CITY OF ALBUQUERQUE

Re: N-Demand Expansion
3810 Academy Parkway NE
30-Day Temporary Certificate of Occupancy
Transportation Development Final Inspection
Engineer's Stamp dated 04-12-22 (E17-D001J)
Certification dated 06-17-24

TRAFFIC CIRCULATION PLAN

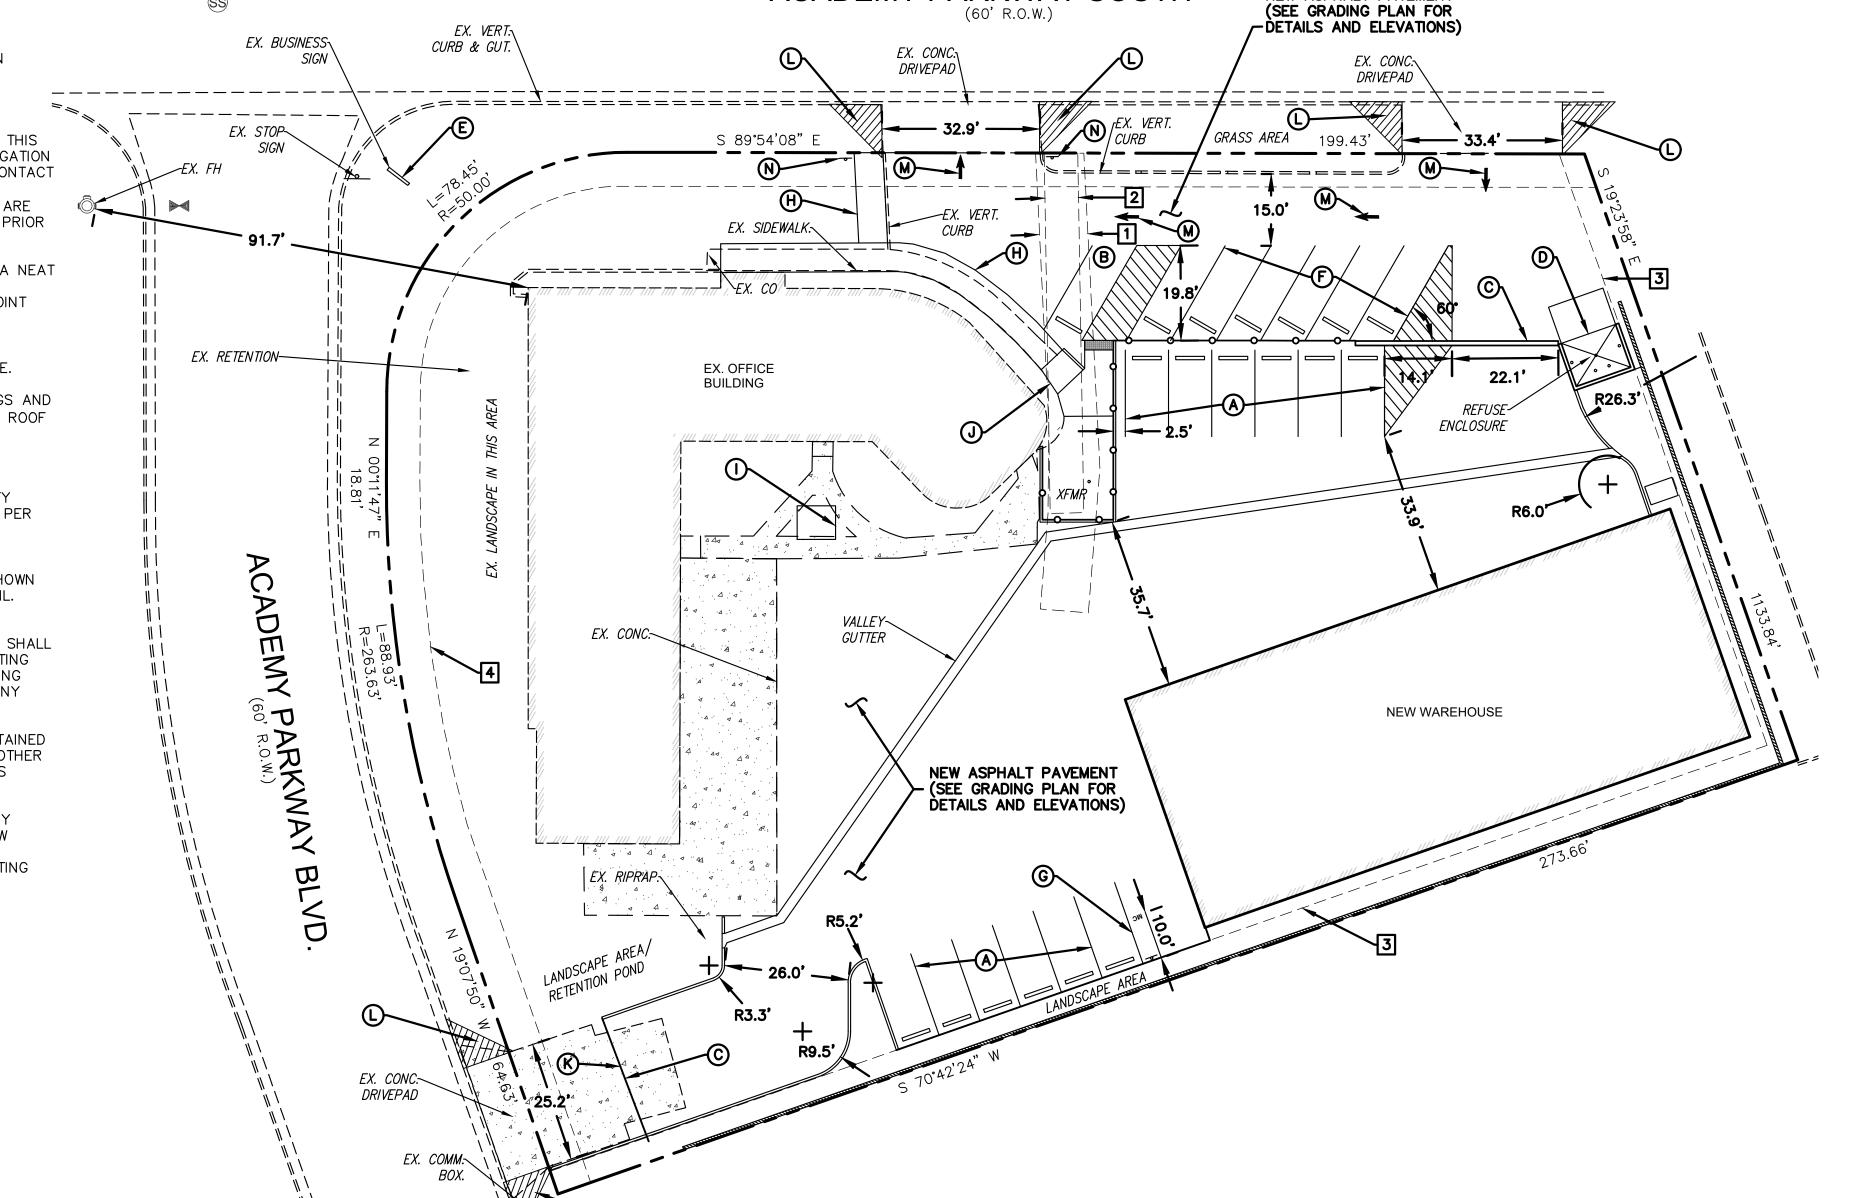
Keynote H: Per the approved plan, the ADA pathway to building entrance must be constructed.

• Due to closed gate and the un accessible site, please send me picture of the bike rack.
